## **MEMORANDUM**

## **COMMUNITY DEVELOPMENT DEPARTMENT**

In the 'Parking Analysis' report prepared for Cedar & Sage Homes [4/16/24] sections 2.0 'Methodology' and 3.0 'Calculations' the Proponent refers to two existing Parking and Access Agreements (in Appendix C and D) that include the subject property and nearby parcels. These parcels are, and will be home to, a number of businesses inclusive of The Bradley, Trilogy Hair Company, La Luna Wellness Studio, Velma Johnson, Longship Cellars, Hampton Inn, Brush Salon, Revel Medspa, and Marsh McLennan Agency. Parking Standards found within Chapter RMC 23.54 are applicable to all of these uses.

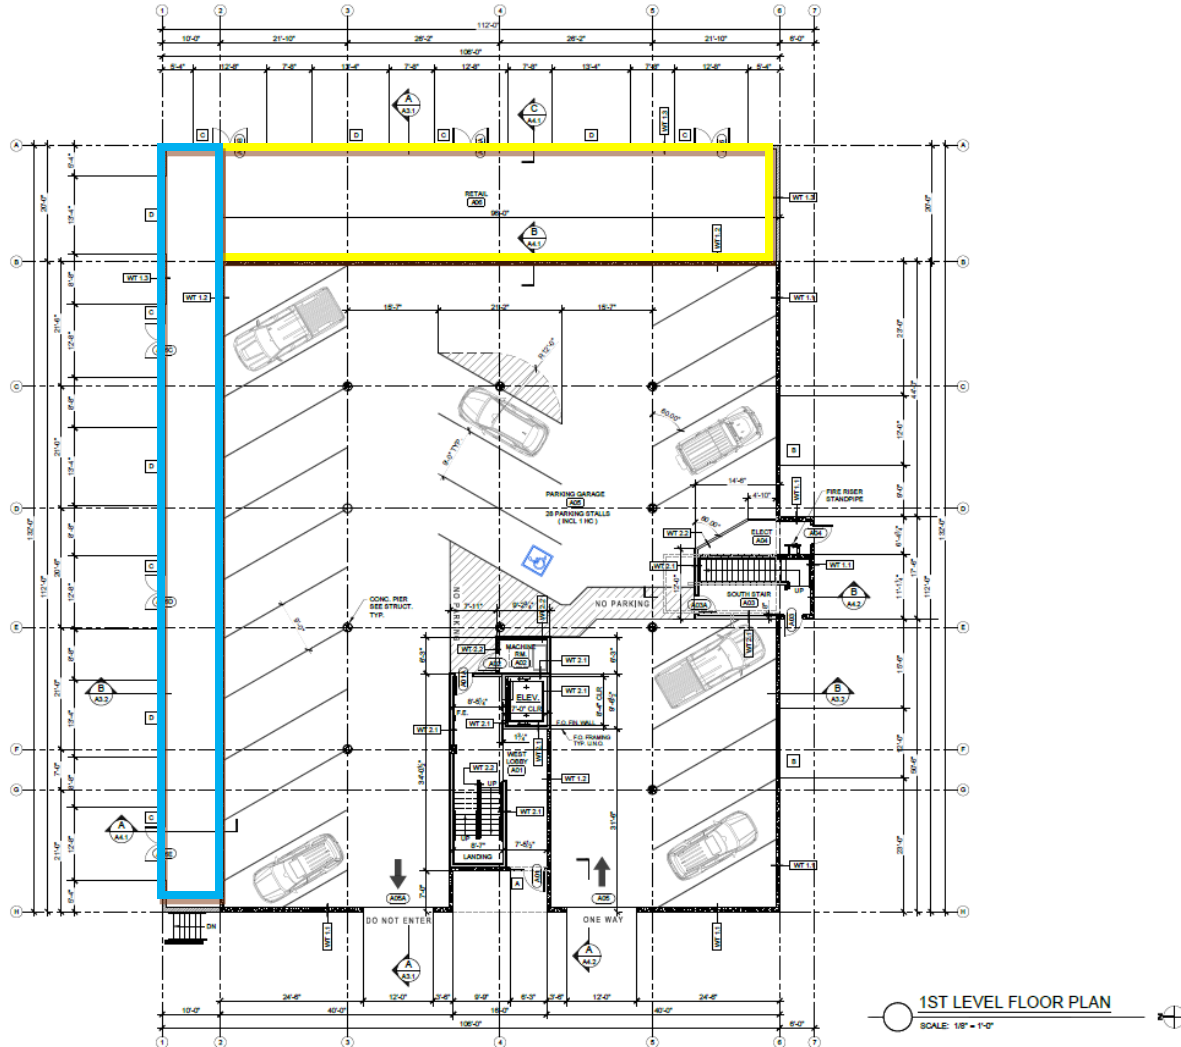
Specific to the proposal at hand, the Proponent calculates that 68 parking stalls would be required to meet Code requirements based on anticipated number of housing units and square footage of anticipated restaurant tenant (see yellow area in graphic, below). However, this calculation omits at least half of the proposed tenant spaces on the north side of the building as demonstrated on Sheet A2.1 (see blue area in graphic, below). Staff would also like to note that the restrictive dimensions of the restaurant use (96' x 22') suggest Proponent might anticipate some dining outside. Whether or not that would be permitted per easements and other restrictions is beyond the scope of this comment, however, please note that Planning counts outdoor dining to parking requirements for restaurant uses per 1 stall to 100 square feet. Outdoor dining would increase parking required for this use commiserate with square footage dedicated to that use.

1. Perform a parking analysis inclusive of all tenants/uses on all properties subject to the reciprocal Parking/Access Agreements.
2. Count the existing number of parking stalls "on-the-ground" within all parking areas subject to reciprocal Parking/Access Agreements.
3. Determine and definitively state the allowed future use types within categories listed in RMC 23.54.020 to be housed within the building. Only by definitively stating what use types will be in the commercial, ground floor areas of this project can the Proponent actually determine their parking requirement.
